# Commission on Disability

December 28, 2021

LexSeeHer is bringing you two key areas for discussion: design of the pedestal / plaza, and size of the pedestal / plaza.

Preliminary Sketch, Dec. 2021

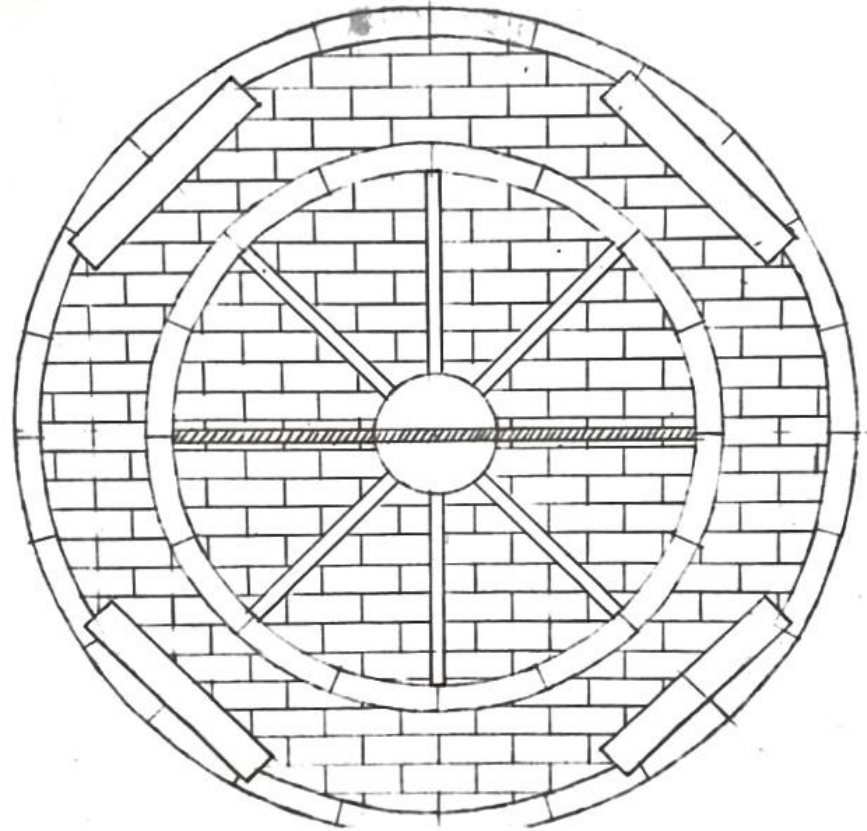
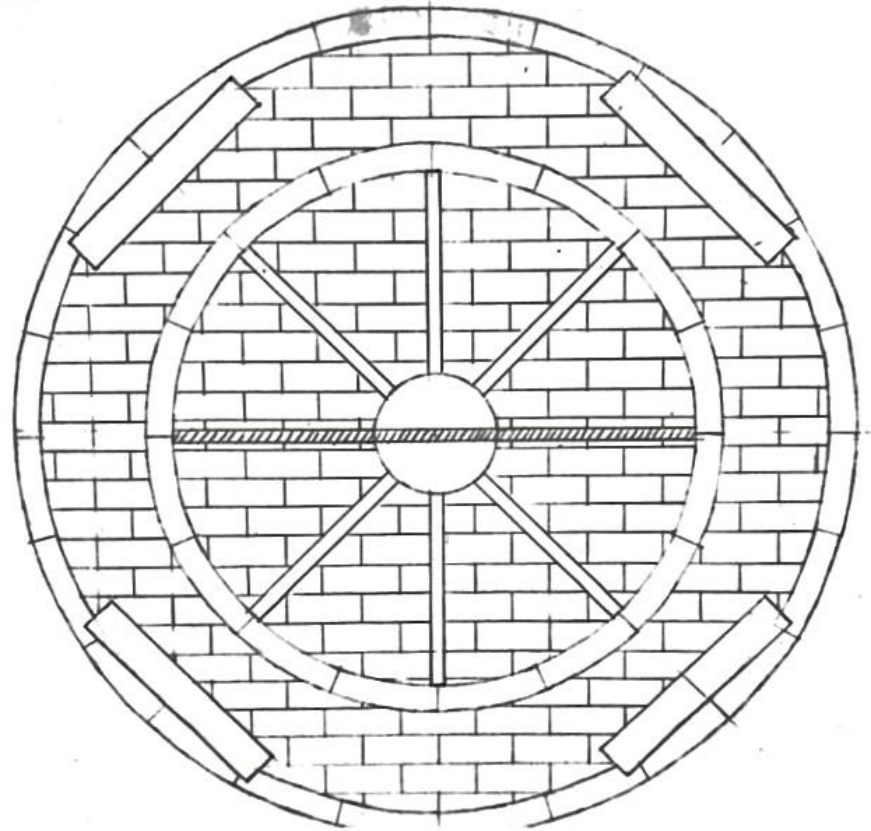
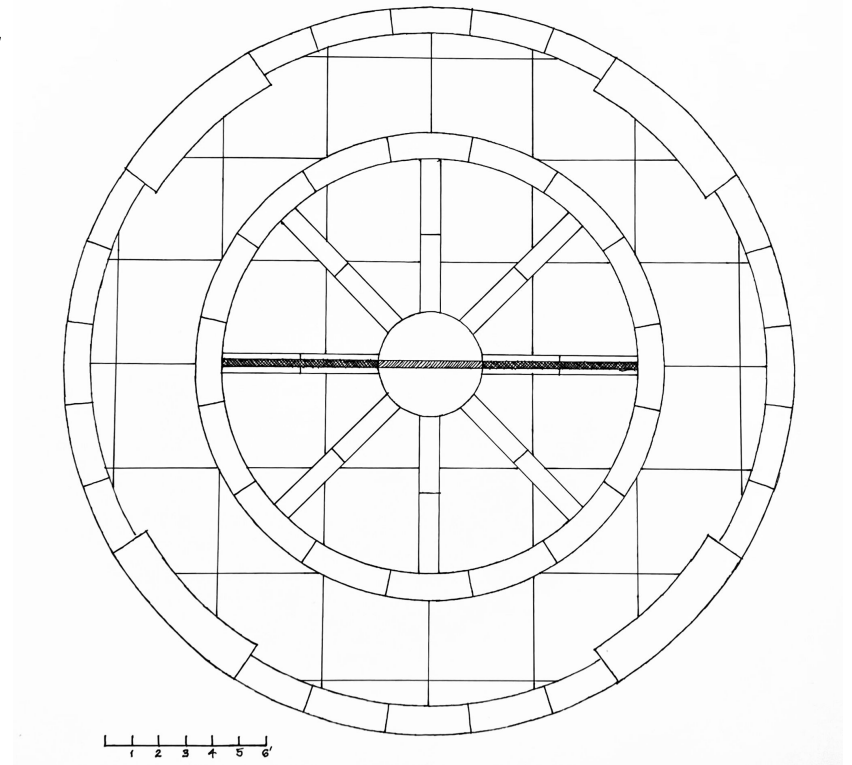
We heard feedback from Commissioners about the pattern. We learned we had the potential to improve the design to make it more accessible and enjoyable for visitors who might find the basketweave pattern too visually noisy or distracting.

Meredith is bringing a new design to you tonight that reduces the number of lines on the plaza, and also enhances the spinning wheel design.

The smaller pavers that would have shown the basketweave pattern are replaced with larger 4' pavers.

The wheel motif is enhanced by making the resting places curved.

Revised proposal:

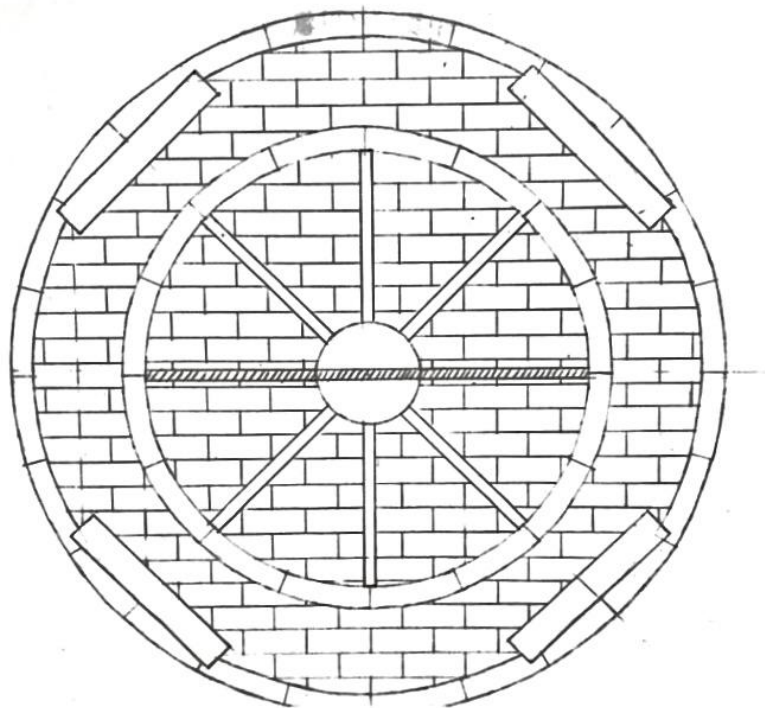
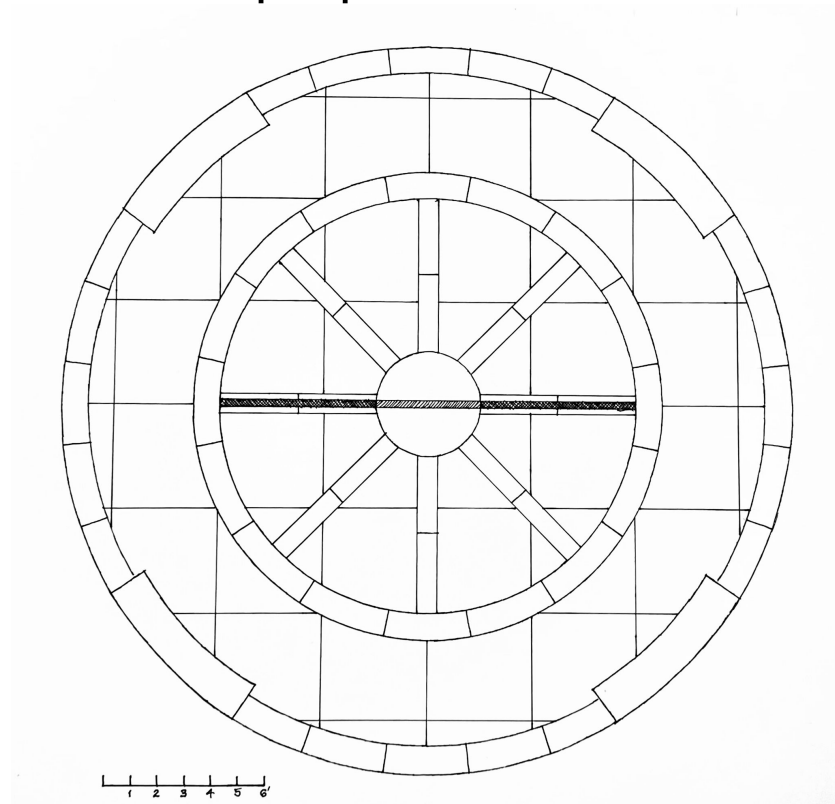
Original proposal:

Revised proposal (28’):

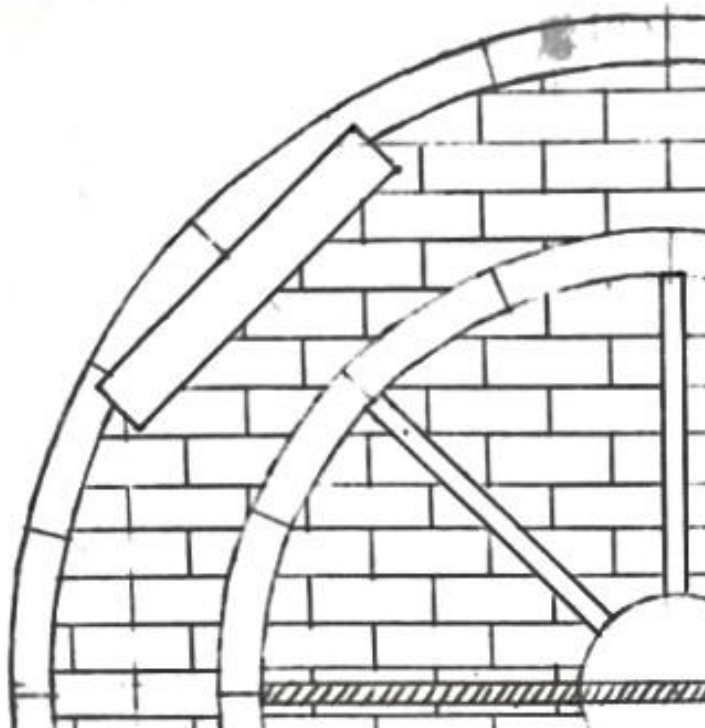
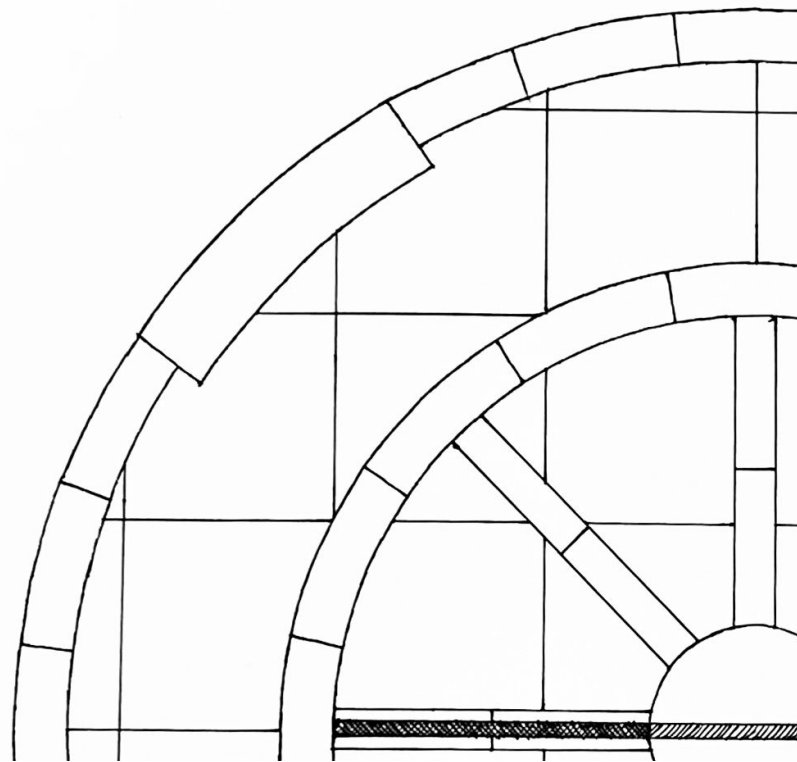
Original proposal (24’):

Dimension of new plaza: 28' diameter

Pavers: standard 3" thick
